## Index 711-003 Interchange Markings

### COMMENTARY

### COMMENTS AND RESPONSES

**TYPICAL INTERSECTION**

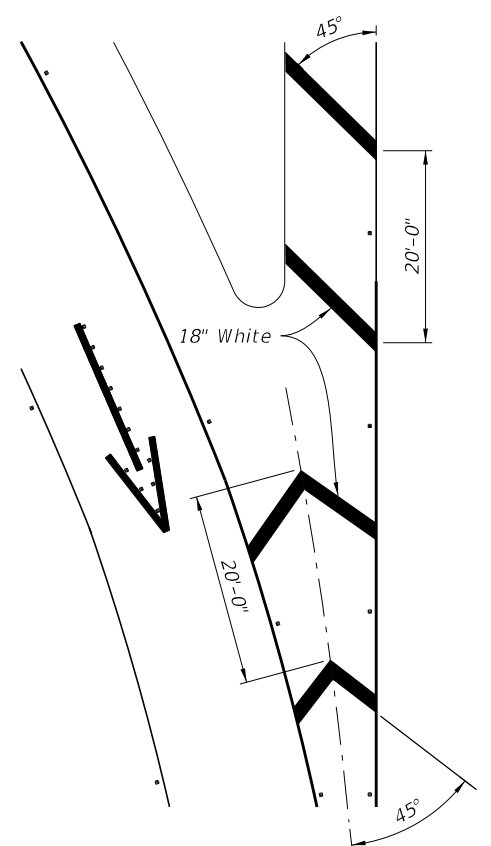
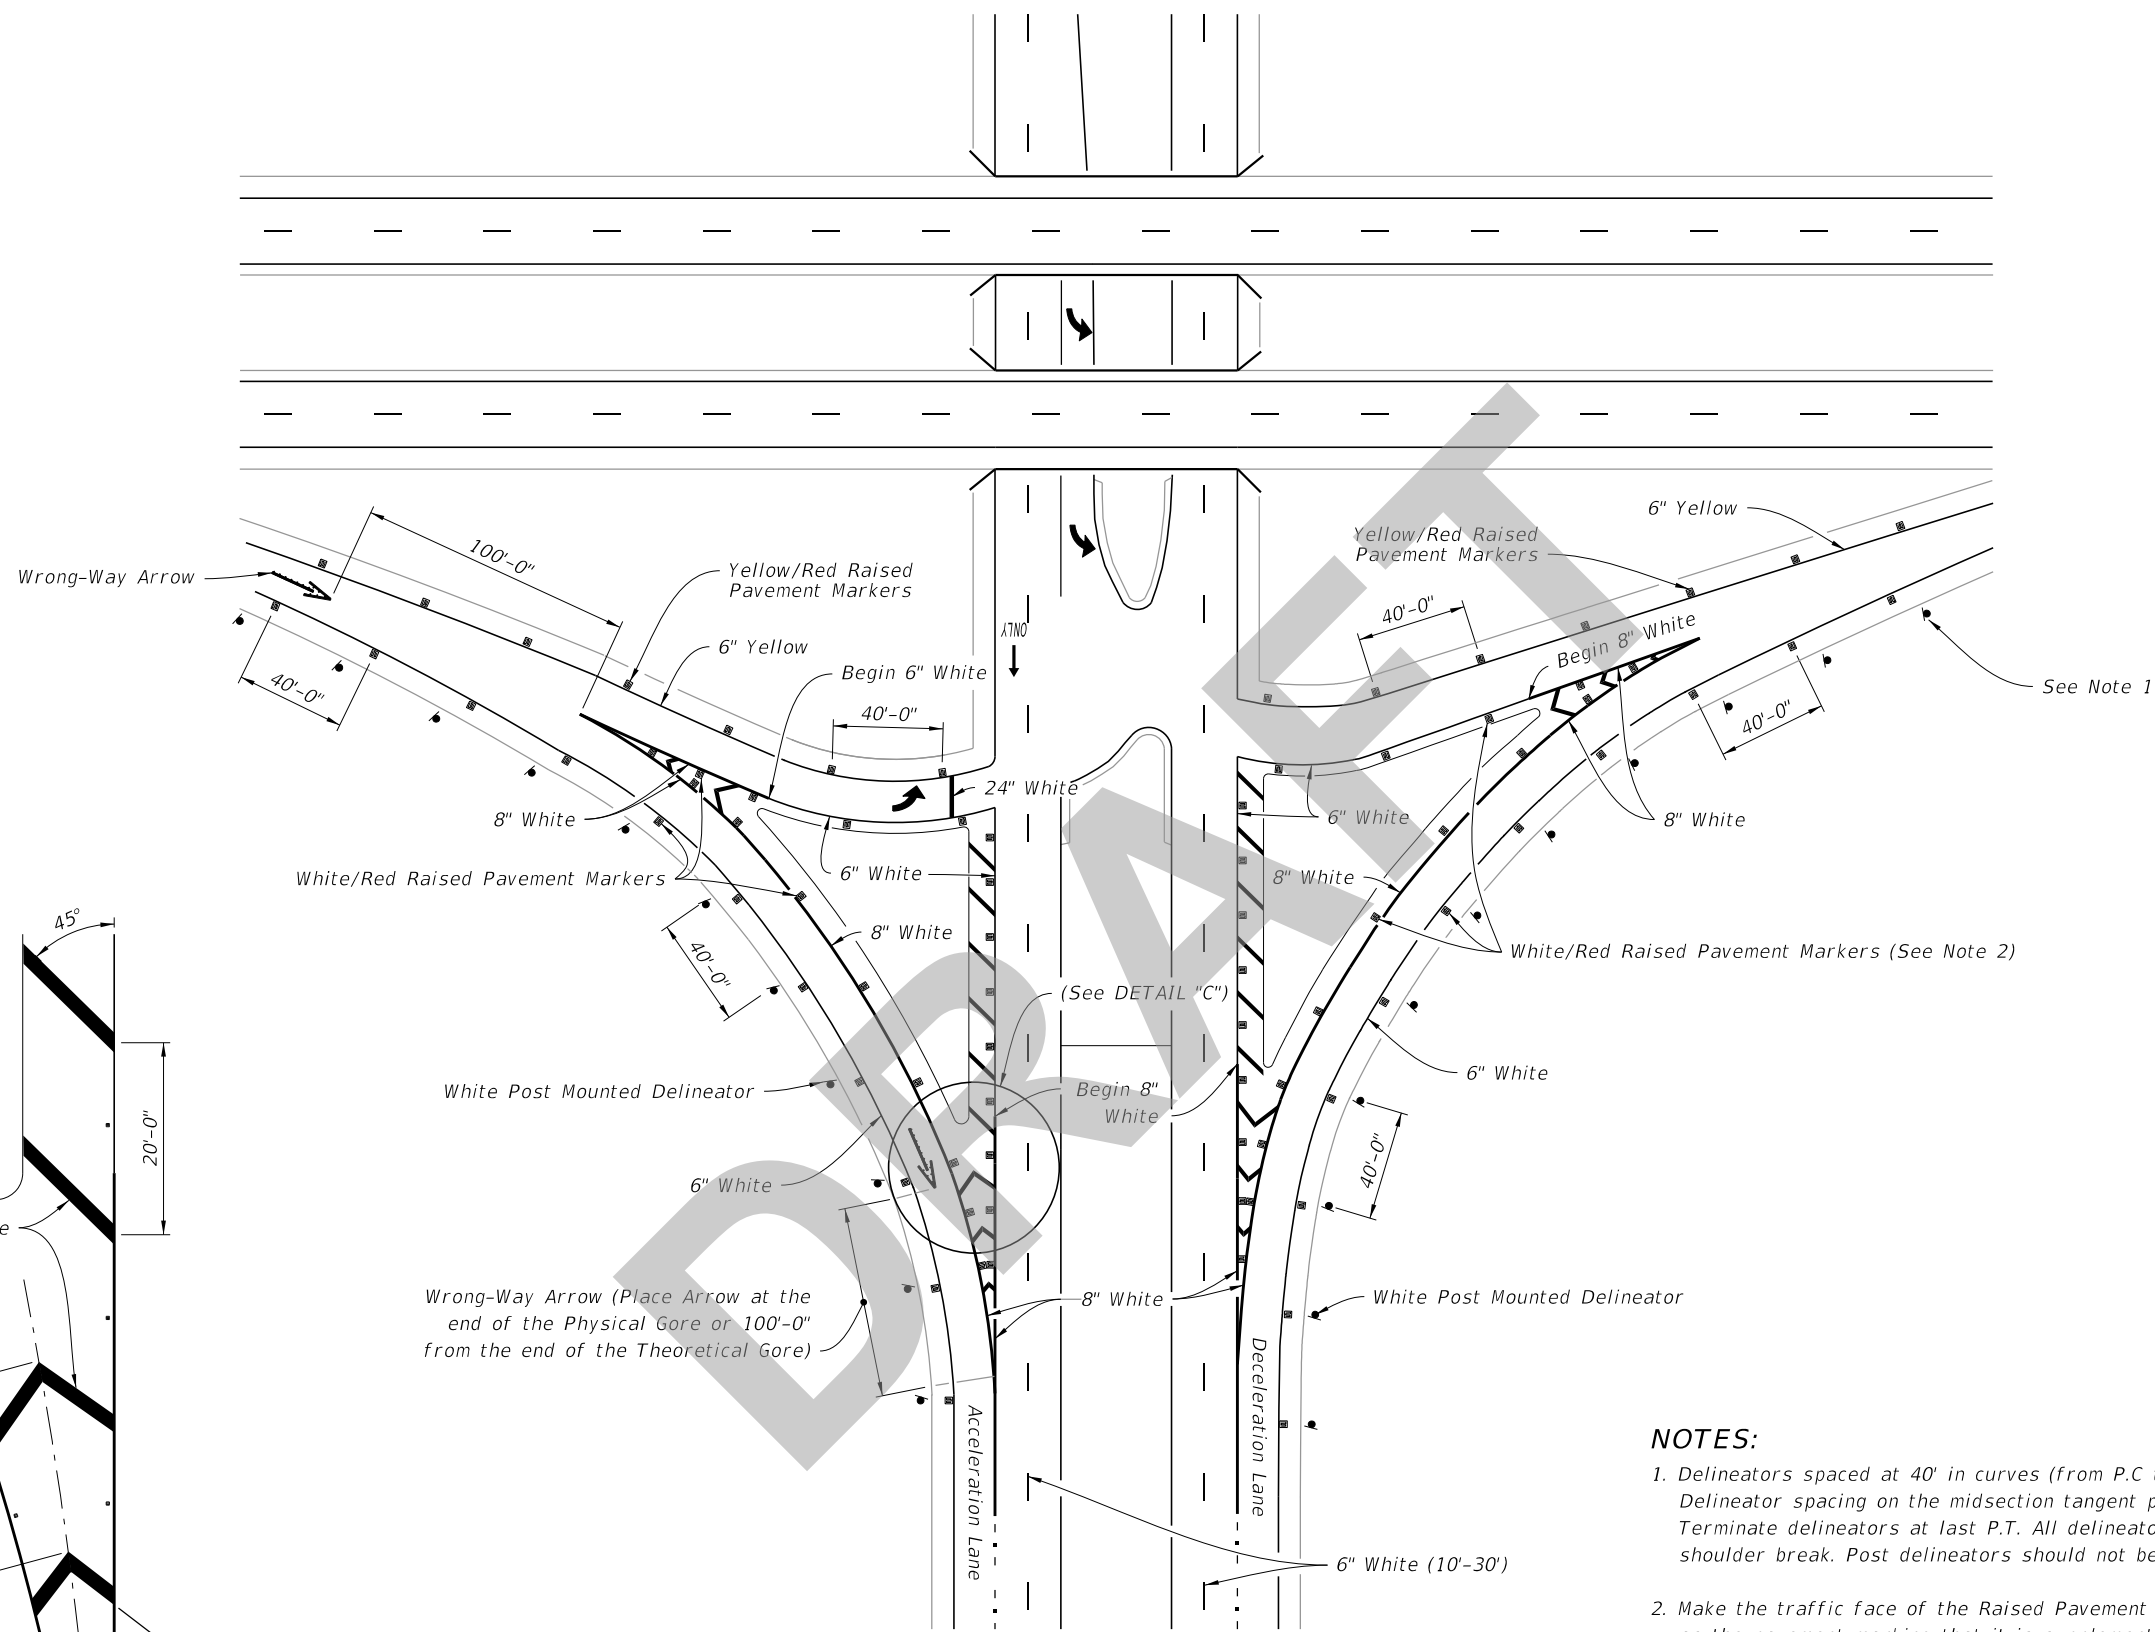
**COMMENT:** 1. On the top left side of the typical intersection, it would make more sense to indicate the 'Begin 6" White' rather than 'Begin 8" White', consistent with the traditional "left-to-right" direction or order.

2. The chevron pavement markings located in the middle of the typical intersection (adjacent to the 4 lanes divided roadway) should be labeled '18" White' markings.

3. Show the spacing dimensions for the roadside hatching/RPMs located in the middle of the typical intersection (adjacent to the 4 lanes divided roadway).

**RESPONSE:** Agreed to all three of these comments.

**CHANGE MADE TO INDEX:** Yes.
